Todo/Changes List

Title: CamCon

Rev: C

10200002

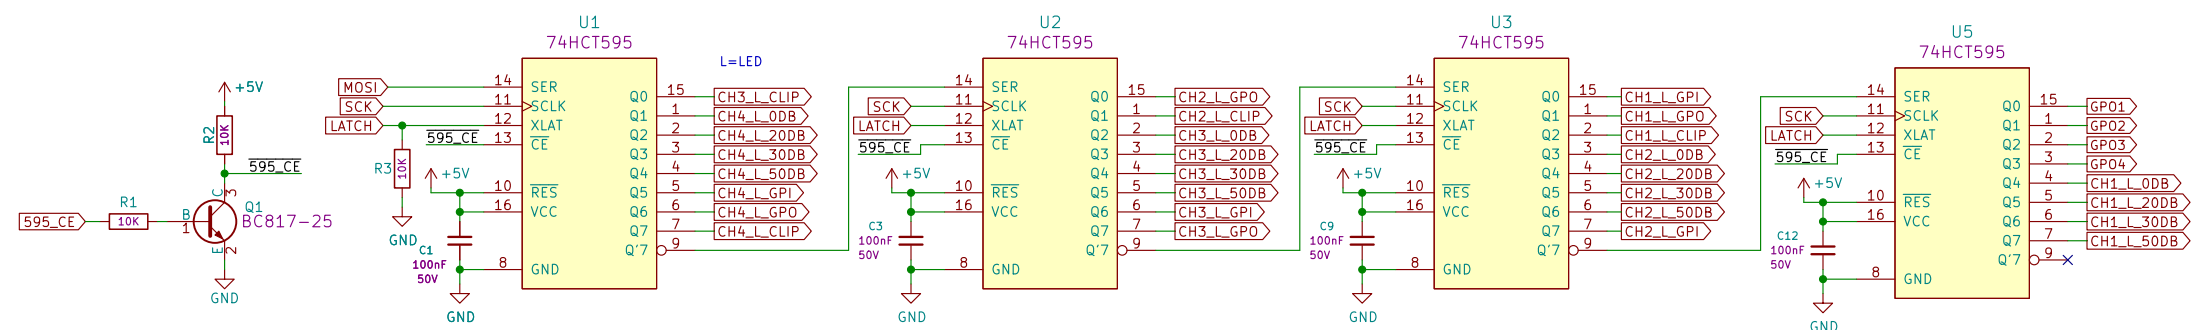
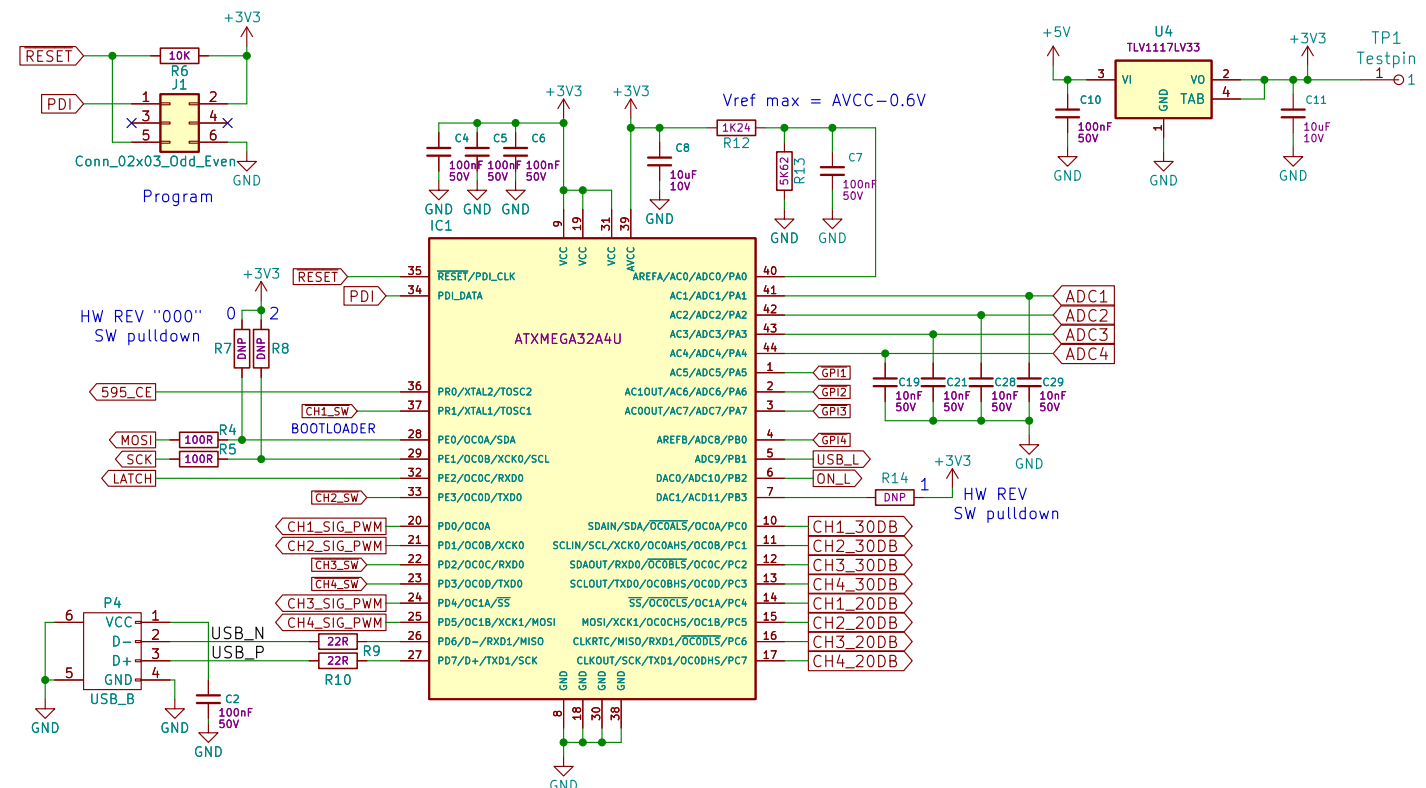
- +30dB too high: gain set resistor 68R changed to 133R (10353853)
- When +11dBu in at 0dB gain is required, decrease gain: R115, 116 ... 10K-->15K

(Migrated from version with RPI and ethernet stack. Updated rectifiers, added new +5V psu, added front leds, added front switches, added PSU to main pcb)

- Move USB connector in line with other connectors (now too far back)
- Make mounting holes oval -done/M
- Add protection diodes to rectifier outputs -done/M
- Make input coupling cap DNM if xformer != used (C41 etc) -done/M
- Make switch footprint THT holes tighter -done/M
- Switch from LRS-35-12 to IRM-5-5 due to 1khz hiccup -done/M
- Delete TPS 5V PSU -done/M
- Move switches 1.5mm more outwards -done/P
- Left down corner cutout -done /P

Limit bandwidth of micamps (for ch 1: C68, C672 $\rightarrow$ 820pF, R84 $\rightarrow$ 10k, R82 $\rightarrow$ 1k1) -done/M

- change leds from 0805 to 3528 to prevent bleeding (@5V blue and red = 2k, green = 470R, green @3v3 = 100R)
- Change +-15V to +-12V to limit current draw of t1072's

- add USB protection diodes
- add better filtering on $\pm 12V$
